LAND USE APPLICATION COMPLETENESS REVIEW

Subject Property: 1105 Front Street NE

Reference Nos.: 24-106451-PLN (Class 3 Site Plan Review, Tentative Subdivision Plan, Class 1 & 2 Adjustment, Class 2 Driveway Approach Permit)

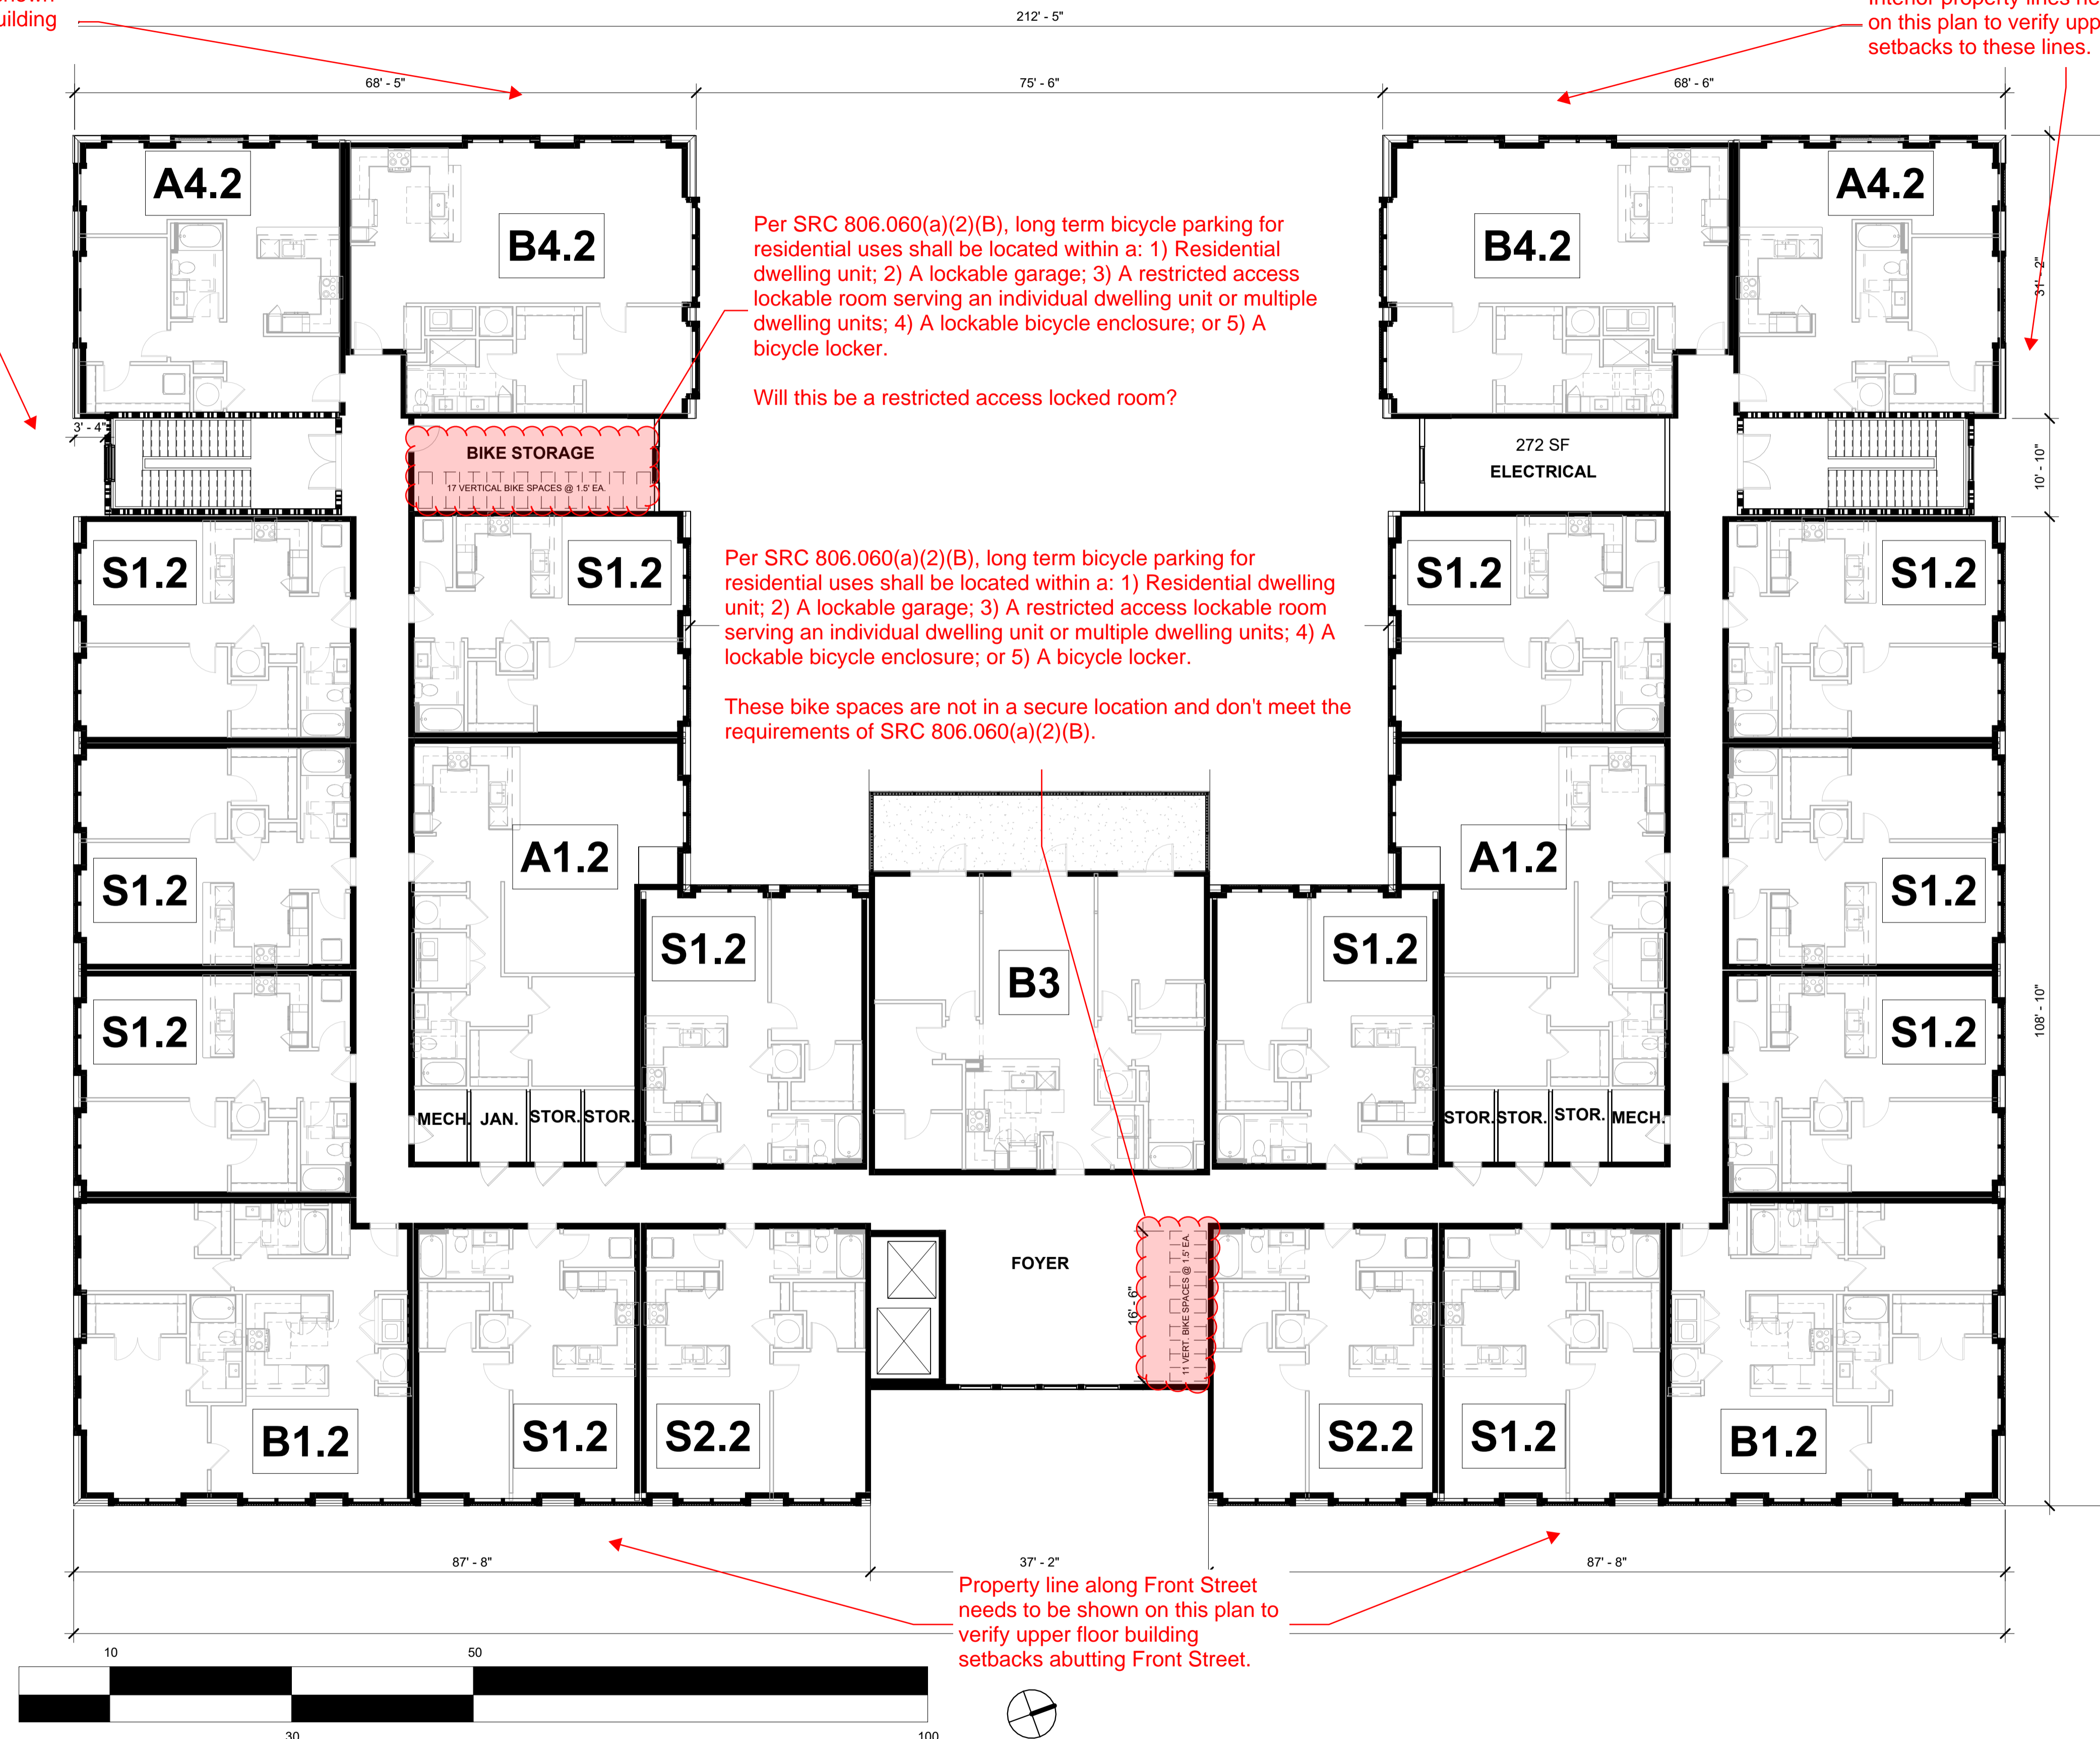
Interior property lines need to be shown on this plan to verify upper floor building setbacks to these lines.

Interior property lines need to be shown on this plan to verify upper floor building setbacks to these lines.

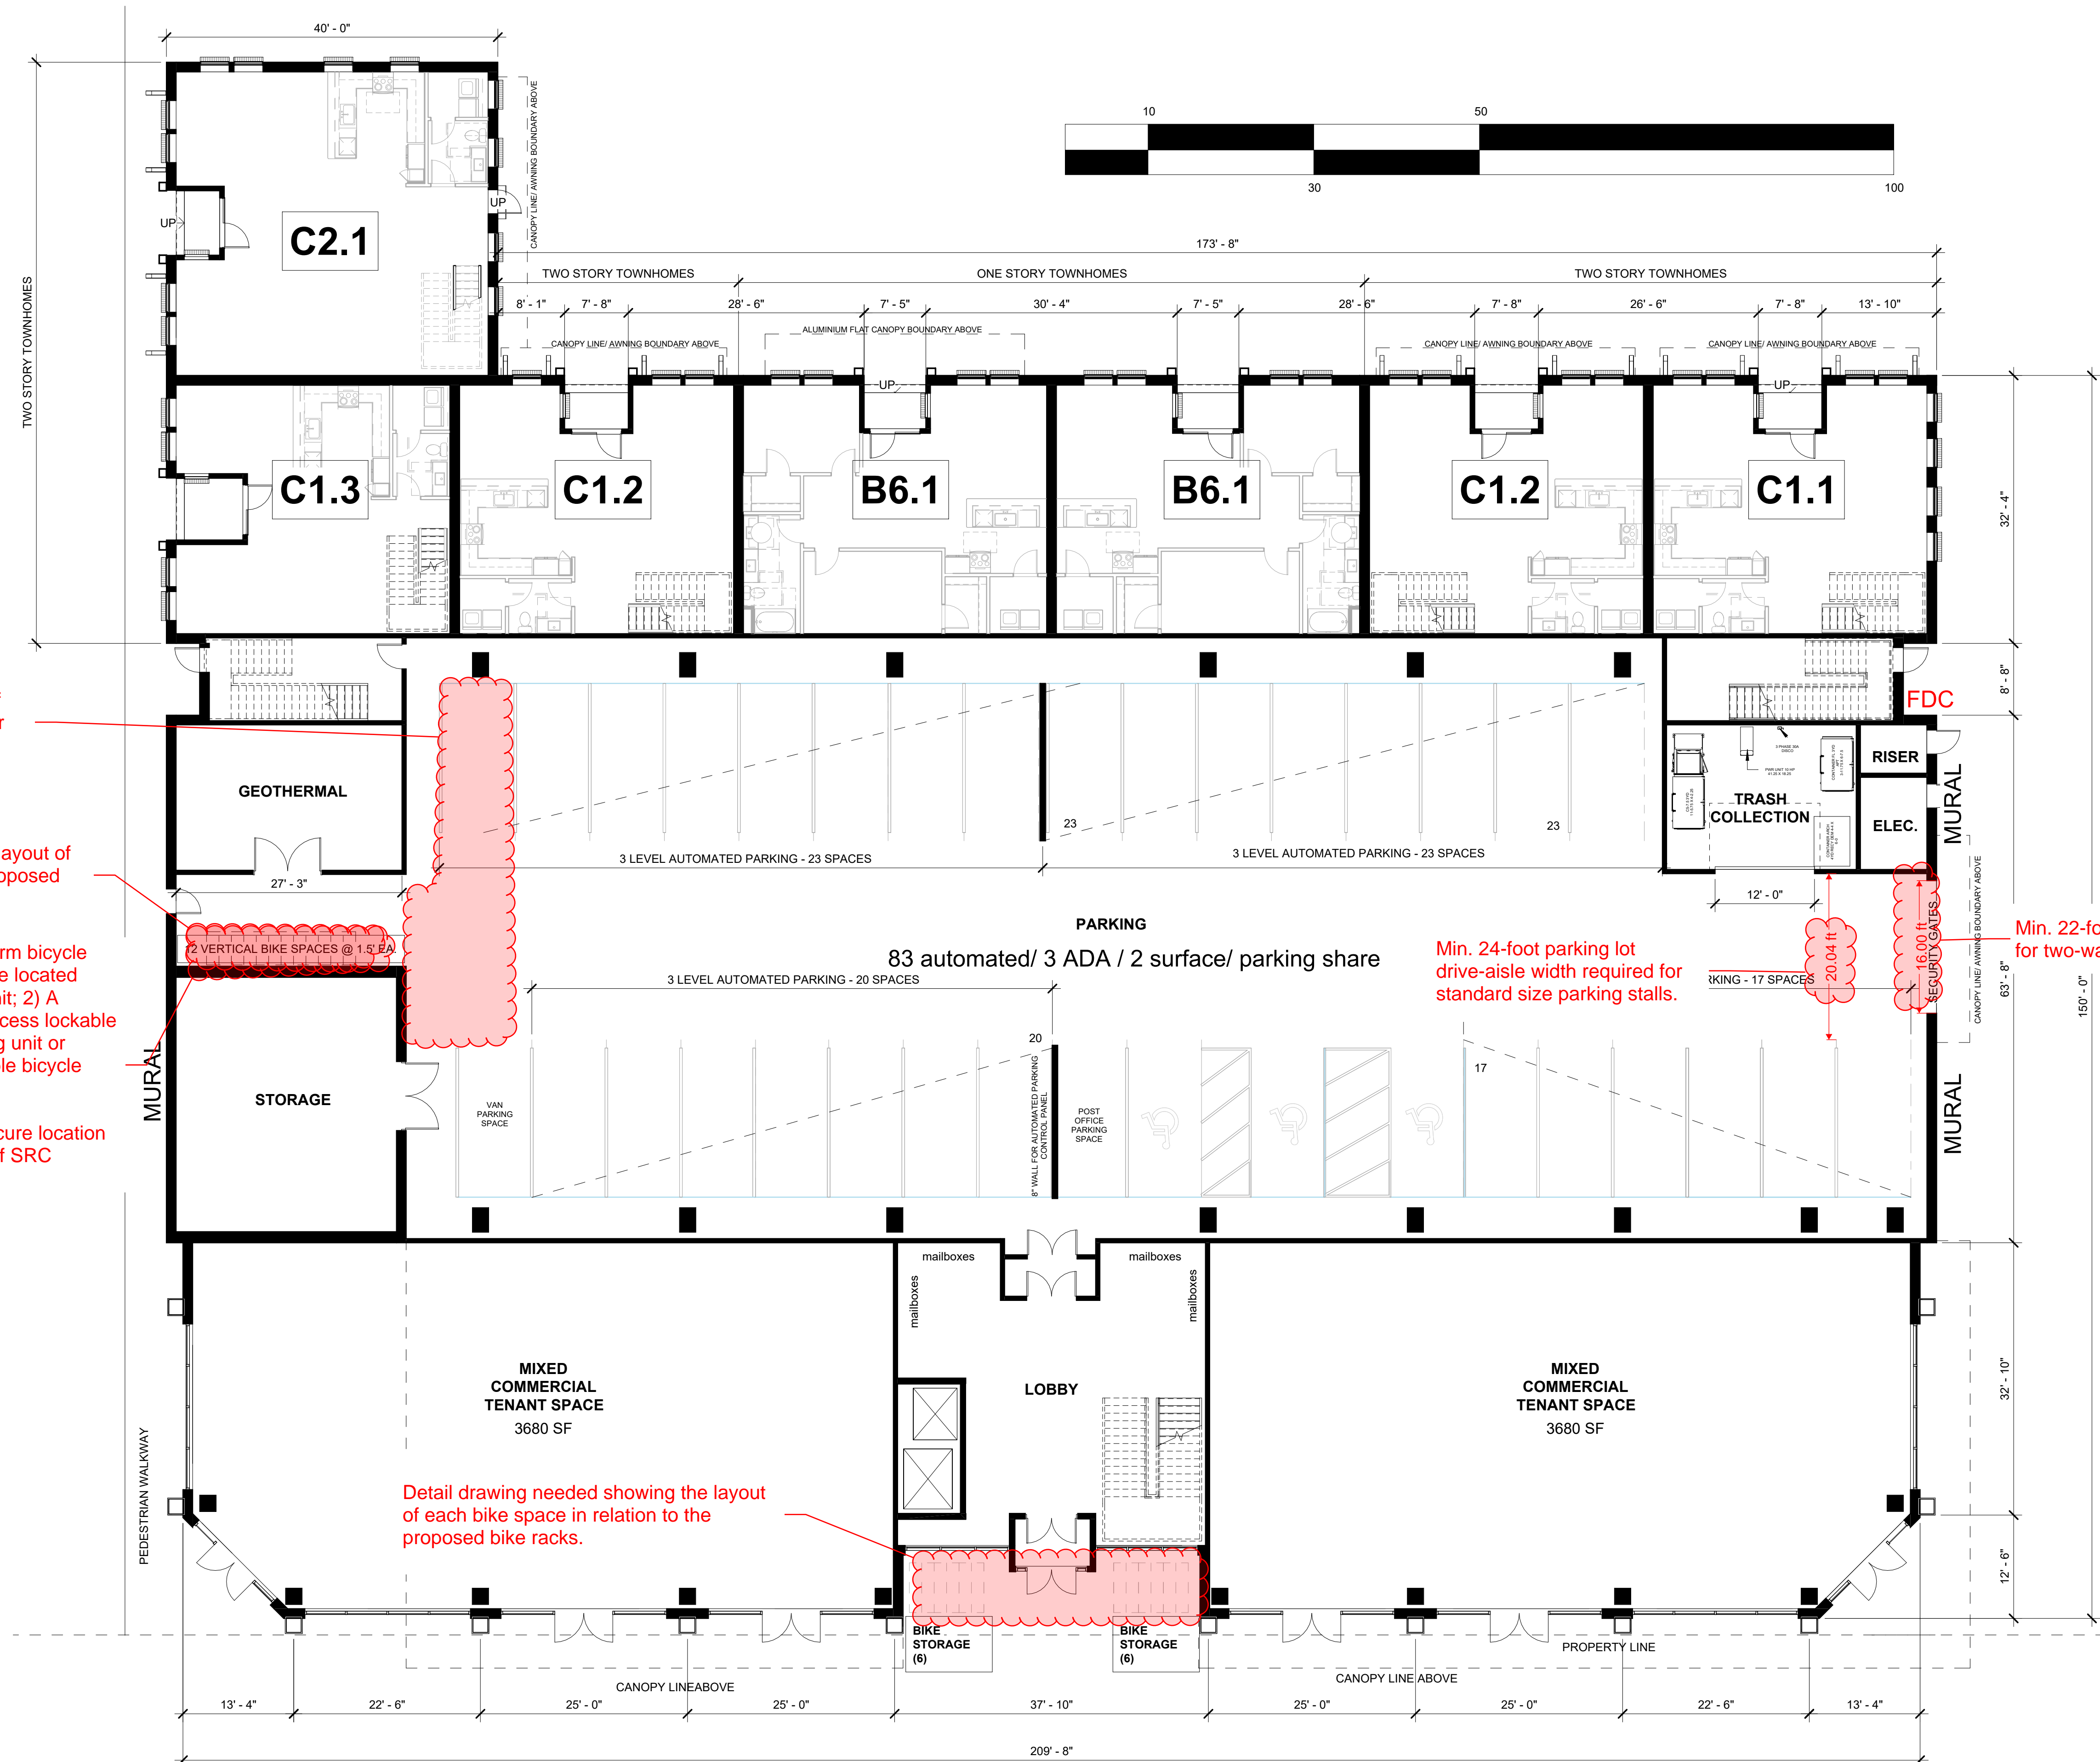
Property line along Front Street needs to be shown on this plan to verify upper floor building setbacks abutting Front Street.

Ground Floor Building Height
 SRC 536.015(g) - Table 536-6 requires buildings with ground floors on primary streets to have a minimum ground floor height of 10 ft. For purposes of this stand ground floor height is measured from the floor to the ceiling of the first floor. The applicant's written statement indicates that the ground floor height of the building is 18 feet. However, in review of the building elevations it looks like the 18-foot height is measured from the floor of the first floor to the floor of the second floor. Confirmation is needed regarding the ground floor height of Buildings 1, 2, and 3 measured from floor to ceiling of the first floor.

Turnaround required at terminus of dead-end parking lot drive aisle per SRC 806.035(f)(2)

Detail drawing needed showing the layout of each bike space in relation to the proposed wall mounted bike racks.

Per SRC 806.060(a)(2)(B), long term bicycle parking for residential uses shall be located within a: 1) Residential dwelling unit; 2) A lockable garage; 3) A restricted access lockable room serving an individual dwelling unit or multiple dwelling units; 4) A lockable bicycle enclosure; or 5) A bicycle locker.

These bike spaces are not in a secure location and don't meet the requirements of SRC 806.060(a)(2)(B).

Detail drawing needed showing the layout of each bike space in relation to the proposed bike racks.

Min. 24-foot parking lot drive-aisle width required for standard size parking stalls.

Min. 22-foot opening required for two-way driveway.
